Comments on the LCFS Final Draft California Air Resources Board Meeting to Consider the LCFS

April 23, 2009
Ryan Harty
Honda R&D Americas, Inc

Figure 5: Average GHG emission of the last generator online in CA (2010 demand with current grid mix and median hydro availability)

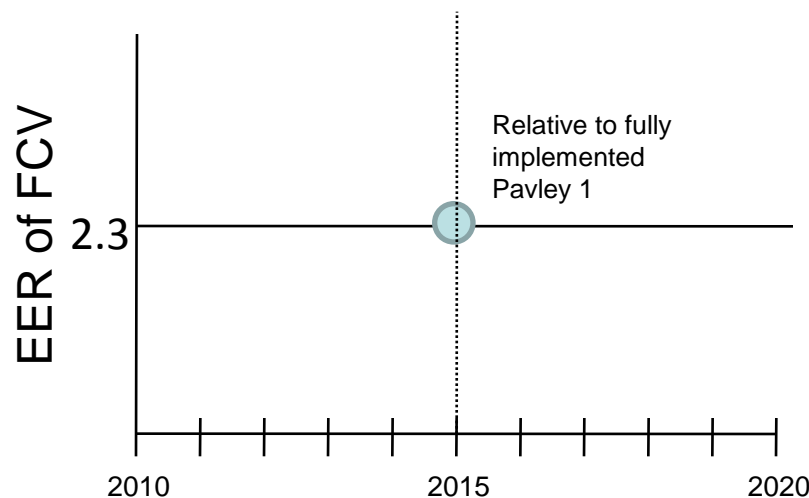
Average marginal generation in 2010, based on the current grid mix, almost always comes from natural gas plants. Emissions range from 393-583 gCO₂/kWh, increasing in late summer afternoons when demand is high and hydro availability is low. In the near term, vehicles will use electricity that is more GHG-intensive than the average mix (in Figure 4), even if recharged at night.

Real EVs plugged into a real grid in California will produce emissions much higher than the “Marginal Electricity” estimate of the LCFS for the near future.

Note UC Davis’ comment: “... In the near term, vehicles will use electricity that is more GHG-intensive than the average mix... even if recharged at night.”

FCV EER (Current Draft)

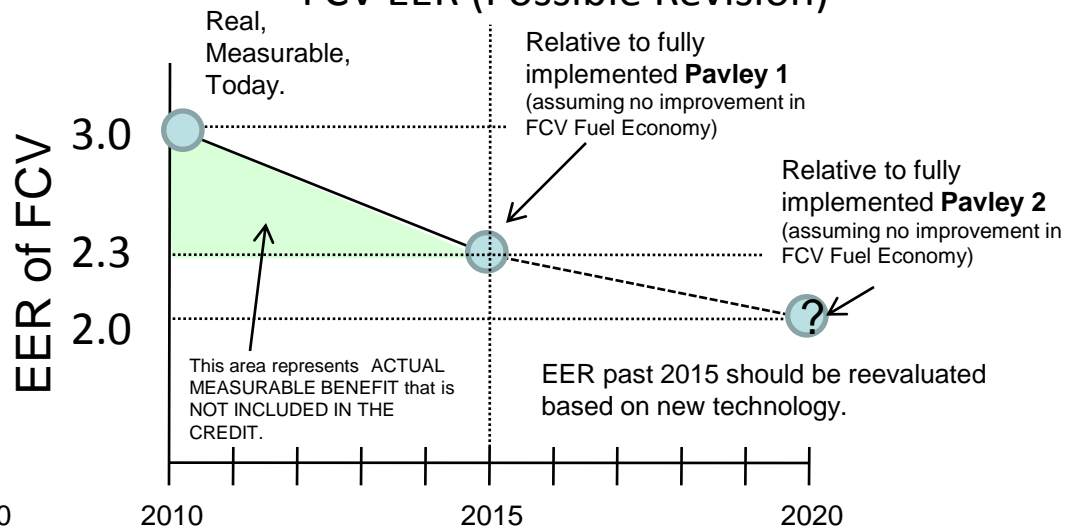
- FCVs actually **do** have an EER of 3.0 vs similar conventional gasoline vehicles **today** and should be rewarded as such. EVs have a similar higher EER today, approximately 3.5, not 3.0.

- The FCV EER of 2.3 in the LCFS Draft takes into account AB1493 regulations, which call for gasoline vehicle fuel economy increases from 2009 to 2015, and sets the 2015 fuel economy of the gasoline vehicle as the baseline against which the 2010 FCV is judged today.

- This is effectively a disincentive to investments in FCVs and hydrogen stations for the next 5 years compared to the actual realizable benefit of these investments. This is opposite to the intent of the LCFS!

- One option would be to adjust the EER of the FCV each year, in a similar manner to the table shown above.
 - 2015 – EER of 2.3 may be appropriate, considering a 30% improvement in gasoline vehicle fuel efficiency.

- 2020 – EER should be re-evaluated. Considering that by 2020, a significant portion of the gasoline vehicle fleet under Pavley 2 will be hybridized, an EER of 2.0 may be appropriate in the 2020+ timeframe.

- The LCFS should re-evaluate the EER tables every 2-3 years, as the state-of-the market is changing rapidly in automobiles today, and both EVs and FCVs will improve their fuel economy from today's numbers.

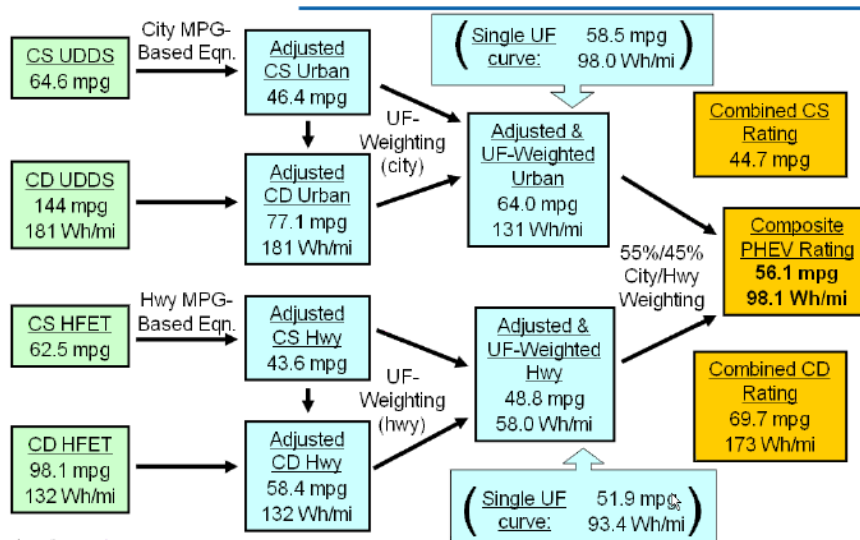
In 2010, the EER is 3.0. Credit for hydrogen fuel cell vehicles in 2010 should be 3.0.

In 2016, the EER is 2.3 (relative to a 2010 FCV!). Credit for hydrogen vehicles in 2016 should be 2.3, assuming there are no improvements in fuel economy of FCVs by 2016.
